Contract #: 04-0120F4Cty: SF/ALA Rte: 80 PM: 13.2/13.9File #: 69.25B**QUALITY ASSURANCE -- NON-CONFORMANCE REPORT****Location:** Changxing Island, Shanghai, P.R. China**Report No:** NCR-000848**Prime Contractor:** American Bridge/Fluor Enterprises, a JV**Date:** 23-Sep-2010**Submitting Contractor:** Zhenhua Port Machinery Company, Ltd (ZPMC), Changxing Island**NCR #:** ZPMC-0810**Type of problem:**

Reference Description: Missed UT Indication: North Tower Lift 5**Description of Non-Conformance:**

NON-CONFORMANCE REPORT TRANSMITTAL

NCR PROPOSED RESOLUTION

Reference Description: Missed UT Indication: North Tower Lift 5

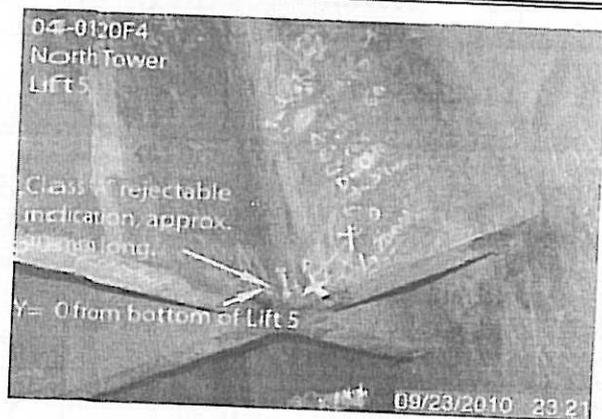
During the Quality Assurance Ultrasonic Testing (UT) review of welds located on North Tower Grillage Lift 5, this Quality Assurance Inspector (QA) discovered the following issues:

- One (1) UT indication measuring approximately 20mm in length, bottom quarter.
- The indication dB rating is a 0 dB.
- The Y distance for this indication is 0 mm from bottom of Transverse grillage plate.
- Material thickness is 65mm.
- The depth of the indication is approximately 54mm.
- The weld is identified as NSD1-TL5-3F-F-28B.
- The weld is a complete joint penetration T-joint weld.
- The indication is clearly marked on or near the weld.
- North Tower Lift 5 is located in Bay 10.

The Notice of Witness Inspection (NWIT) No. is 006751. The indication is located in an area previously tested and accepted by ZPMC Quality Control (QC) personnel. As per the contract documents, ZPMC's QC personnel are required to perform one hundred (100%) percent UT inspection of this weld. For further information, please see the attached picture.

AWS D1.5-02 Section 6; Table 6.3 specifies a class "A" indication as having a rating of +1db and lower for material thicknesses >60mm through 100mm. Table 6.2 specifies 70 degree testing angle for bottom quarter of the weld.

Contractor proposes to repair the weld indication, and provide NDT report to prove the weld is acceptable. Contractor will monitor the inspector who missed the indication, and take disciplinary action should there be similar future occurrences.

Contractor repaired the missed indication completely with submitted NDT documentation support with acceptable results. Contractor is currently monitoring inspector's performance to determine if disciplinary action is needed.
